ADDENDUM NO. 03

TO: PLANS AND SPECIFICATIONS FOR STATE OF MISSOURI

Replace Fire Alarm System, Infrastructure
Farmington Correctional Center
PROJECT NO.: C2503-01

1 **BUILDING 1 - LEVEL 1 - FIRE ALARM**
1/8" = 1'-0"

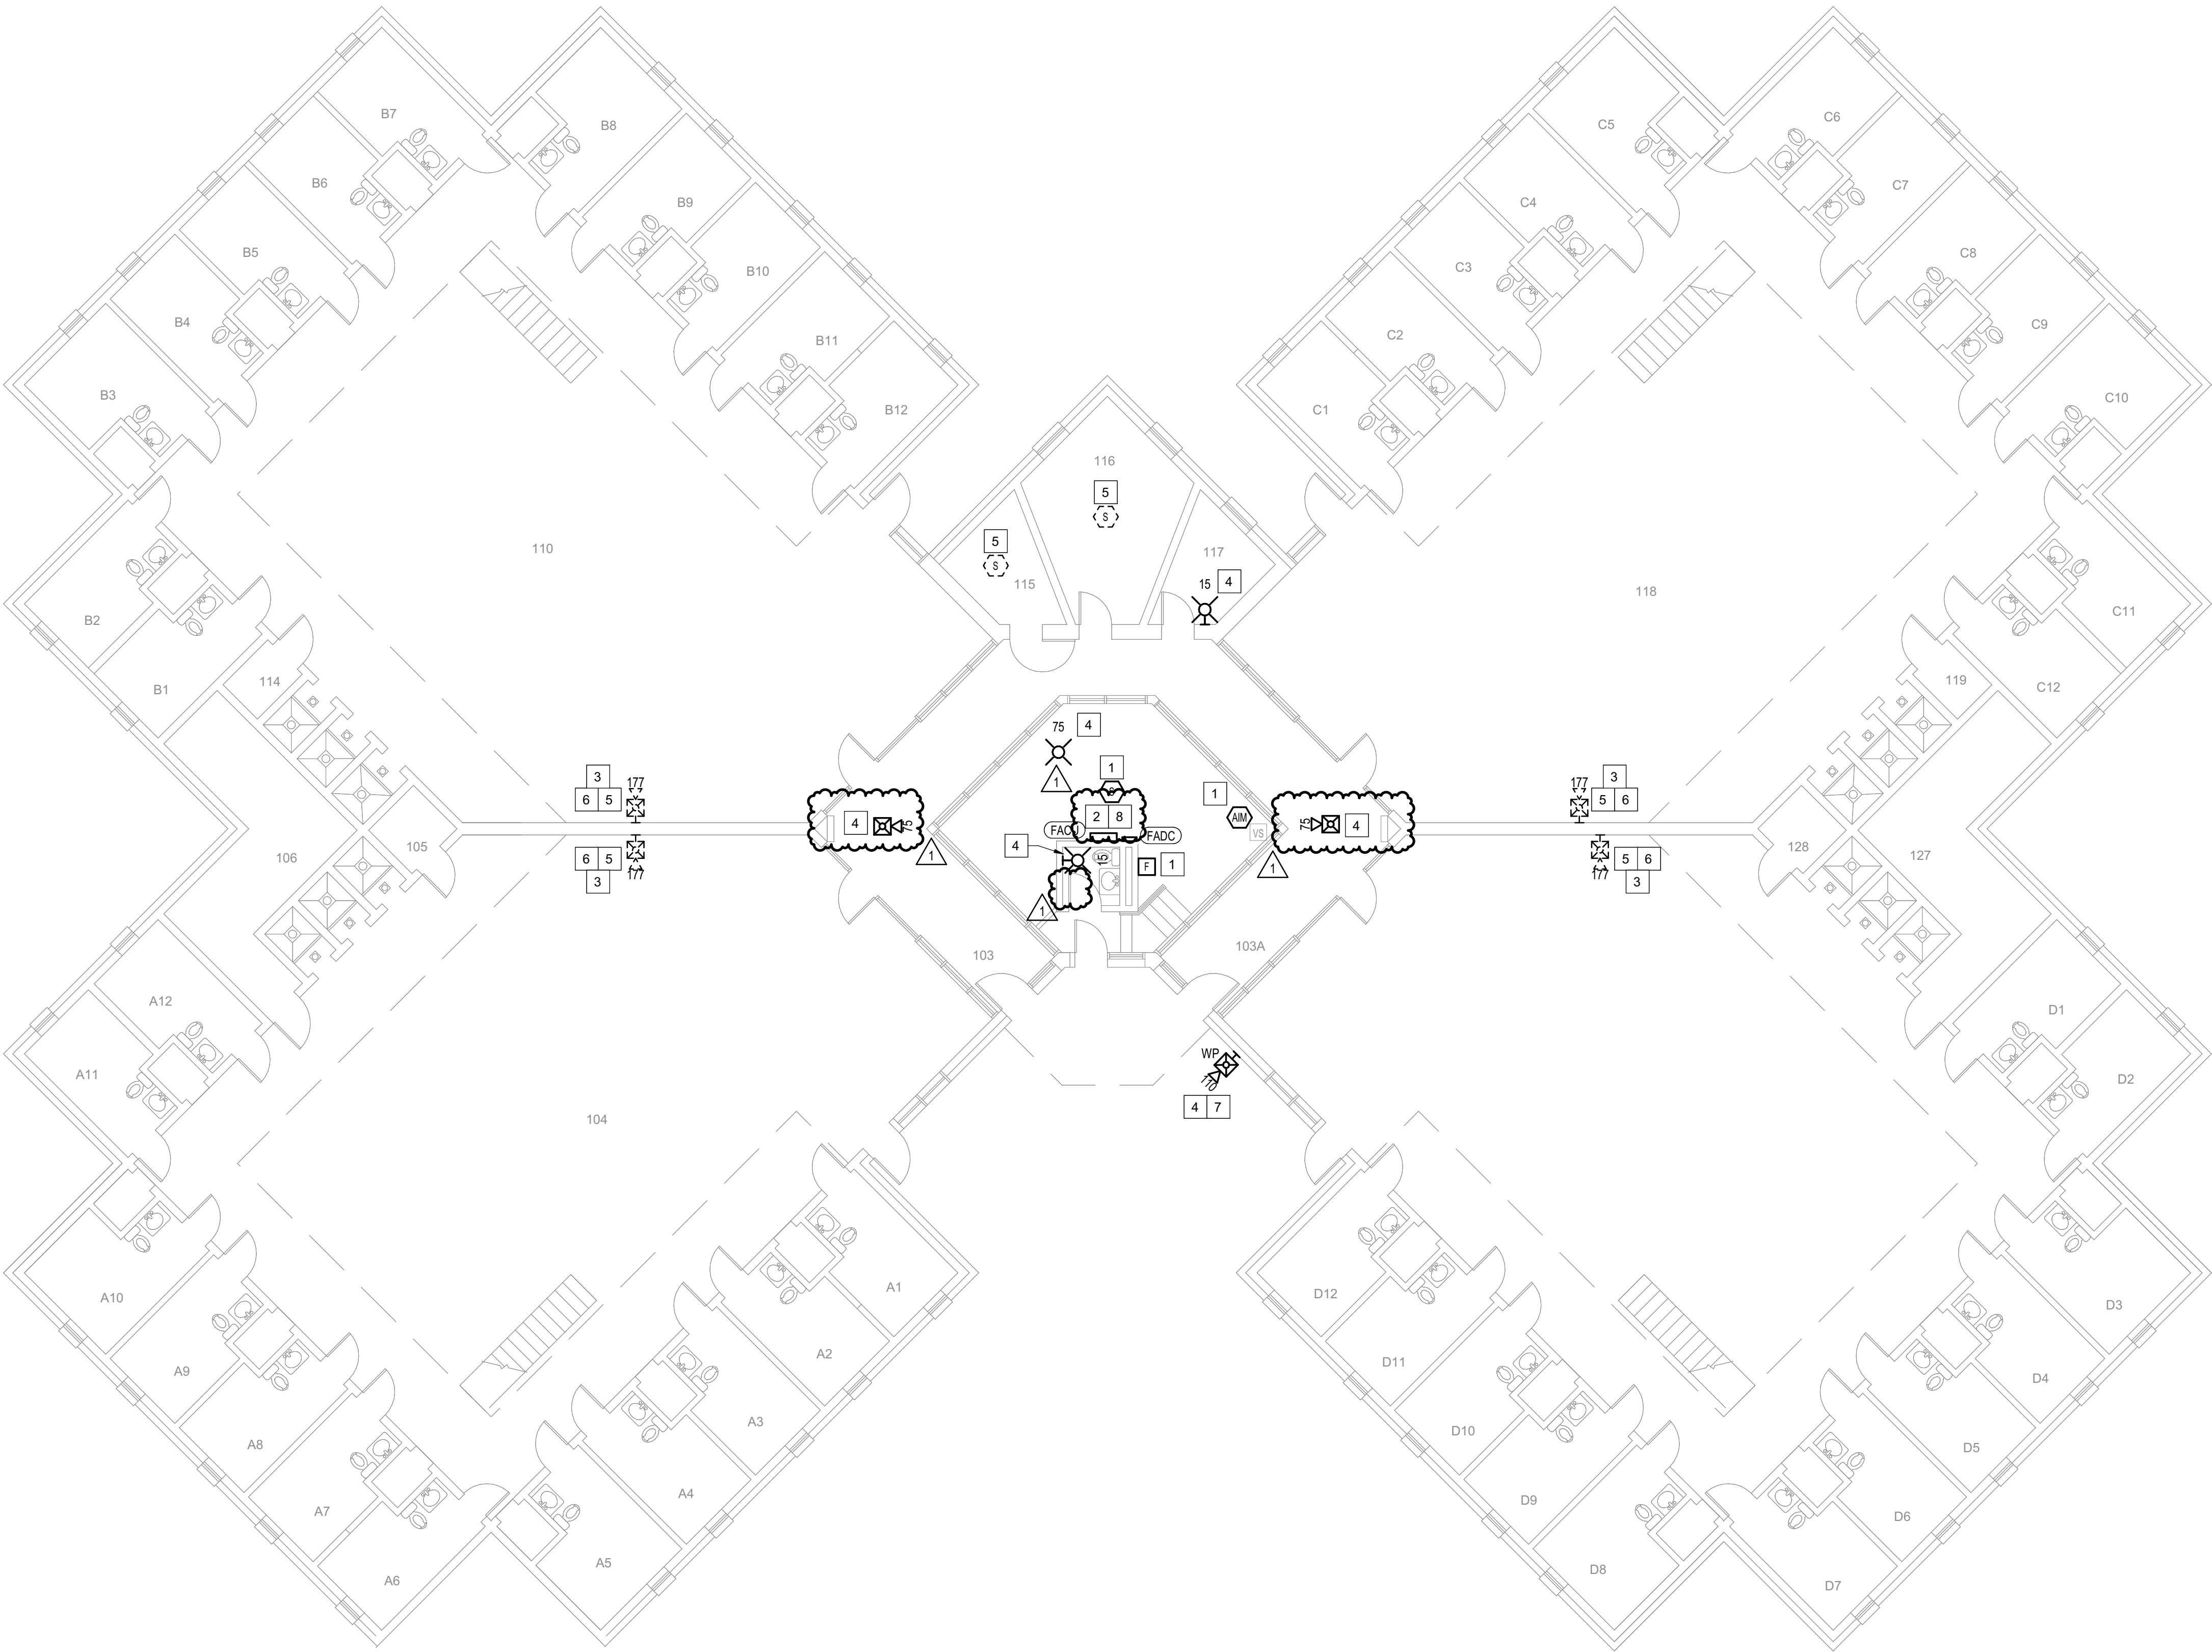
- c. ALTERNATE NO. 3 MODIFIED
 - d. ALTERNATE NO. 4 REMOVED.
- 5. FA101 – BUILDING 1 - LEVEL 1 – FIRE ALARM
 - a. GENERAL SHEET NOTE #2 REMOVED
 - b. NOTIFICATION DEVICES IN THE INNER CORRIDOR SHIFTED TO CEILING MOUNTED.

- c. OLD EXISTING FIBER CABINET REMOVED FROM PLAN TO AVOID CONFUSION WITH NEW FIBER CABINETS.
 - d. SHEET KEYNOTE #8 ADDED
 - e. SHEET KEYNOTE #2 MODIFIED

1 BUILDING 2 - LEVEL 1 - FIRE ALARM
1/8" = 1'-0"

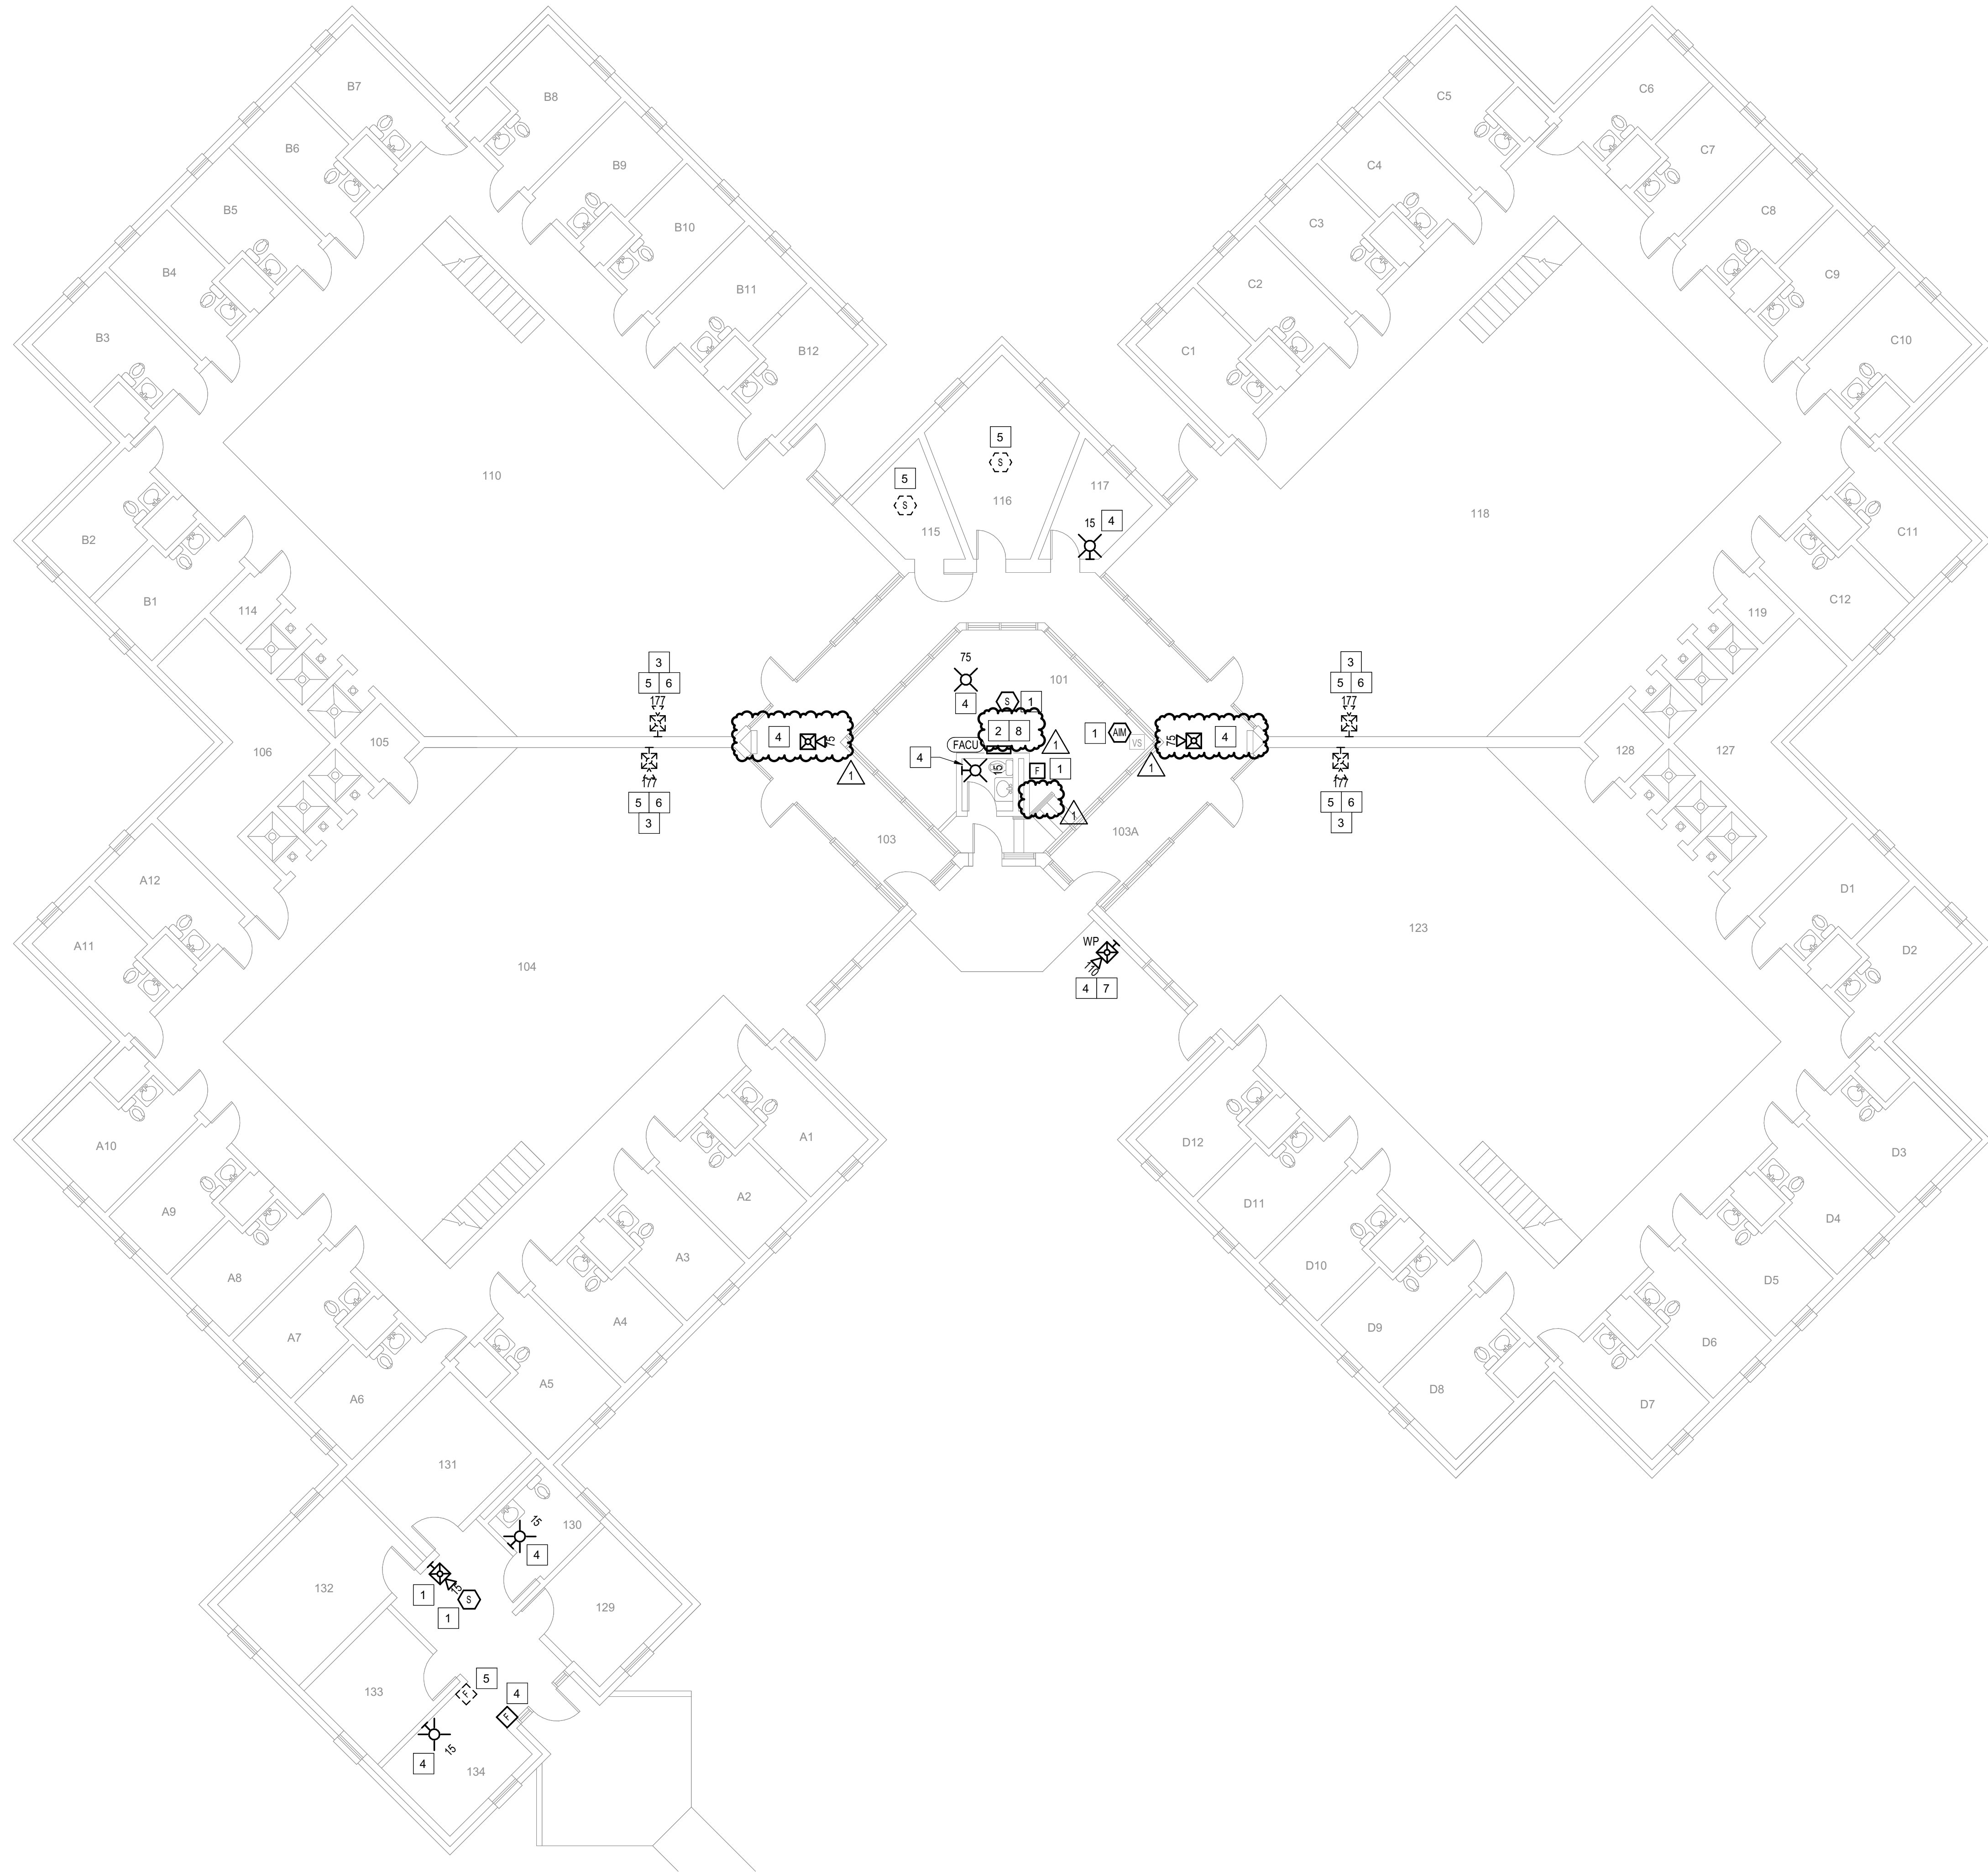
- b. NOTIFICATION DEVICES IN THE INNER CORRIDOR SHIFTED TO CEILING MOUNTED.
 - c. OLD EXISTING FIBER CABINET REMOVED FROM PLAN TO AVOID CONFUSION WITH NEW FIBER CABINETS.

- d. SHEET KEYNOTE #8 ADDED
 - e. SHEET KEYNOTE #2 MODIFIED
- 8. FA104 – BUILDING 2 – LEVEL 1 MEZZANINE – FIRE ALARM
 - a. GENERAL SHEET NOTE #2 REMOVED
- 9. FA105 – BUILDING 3 - LEVEL 1 – FIRE ALARM

1 **BUILDING 3 - LEVEL 1 - FIRE ALARM**
1/8" = 1'-0"

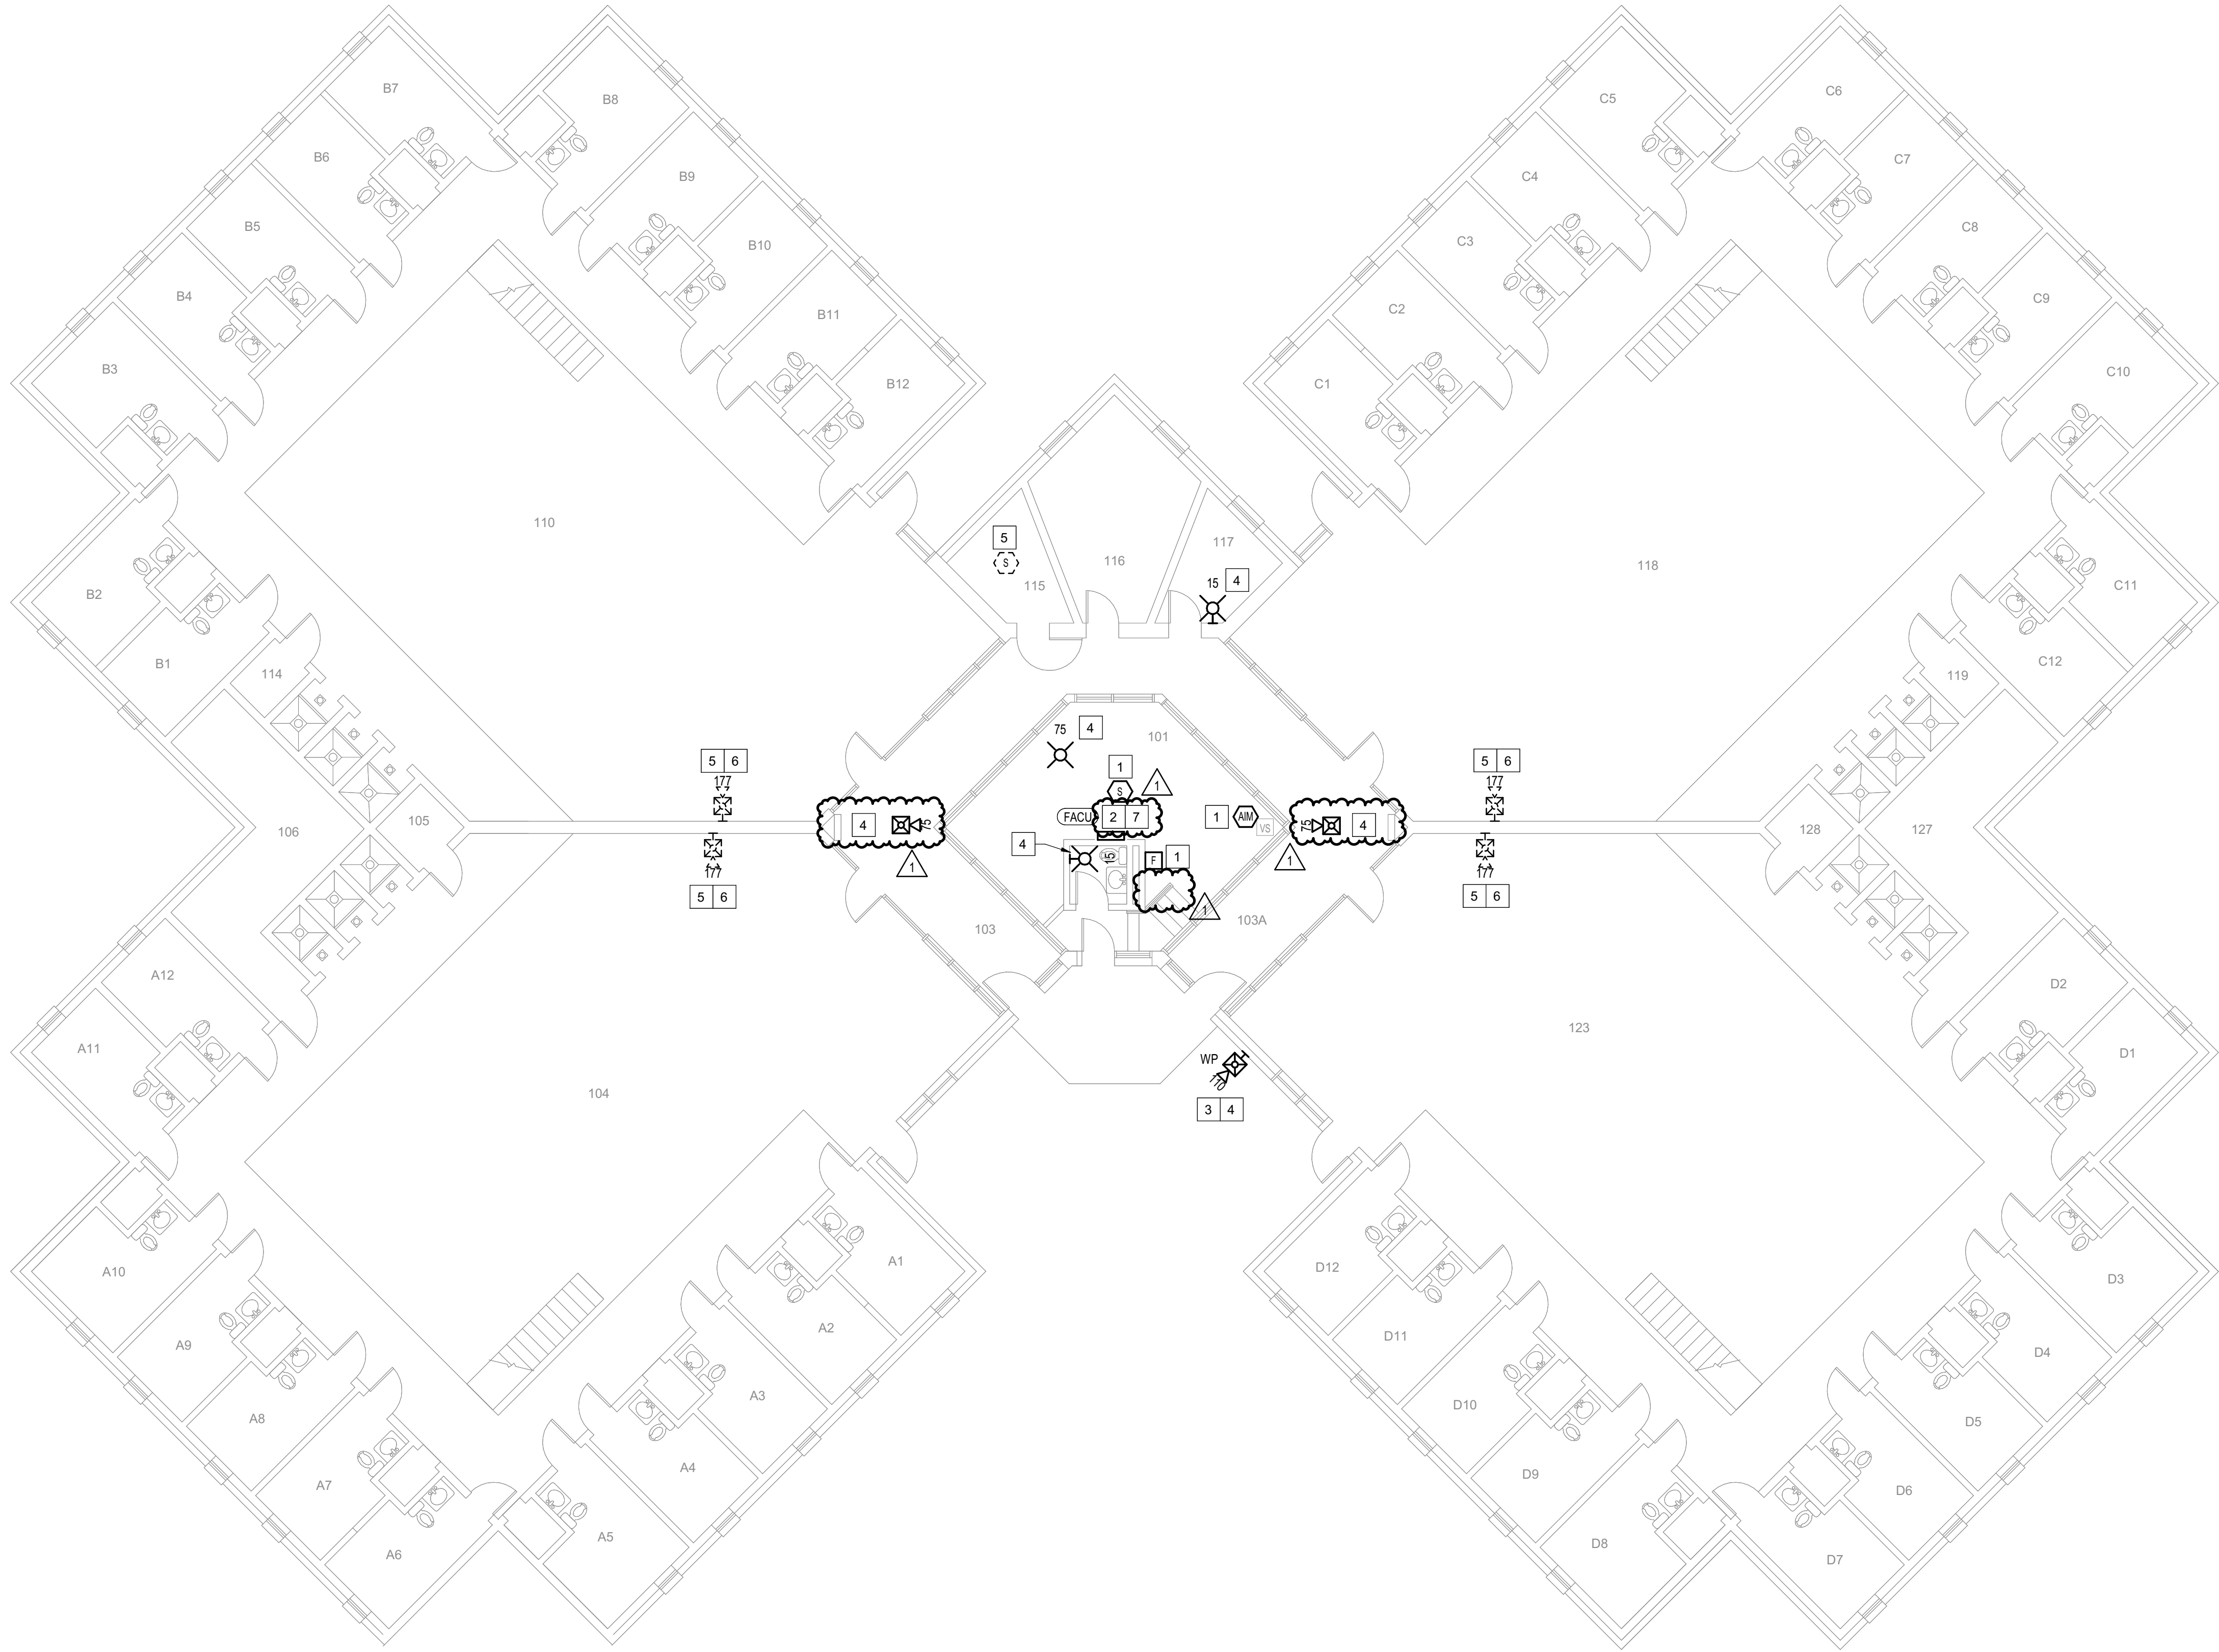
- a. GENERAL SHEET NOTE #2 REMOVED
 - b. NOTIFICATION DEVICES IN THE INNER CORRIDOR SHIFTED TO CEILING MOUNTED.
 - c. OLD EXISTING FIBER CABINET REMOVED FROM PLAN TO AVOID CONFUSION WITH NEW FIBER CABINETS.

- d. SHEET KEYNOTE #7 ADDED

- e. SHEET KEYNOTE #2 MODIFIED
10. FA106 – BUILDING 3– LEVEL 1 MEZZANINE – FIRE ALARM
- a. GENERAL SHEET NOTE #2 REMOVED
11. FA107 – BUILDING 4 - LEVEL 1 – FIRE ALARM
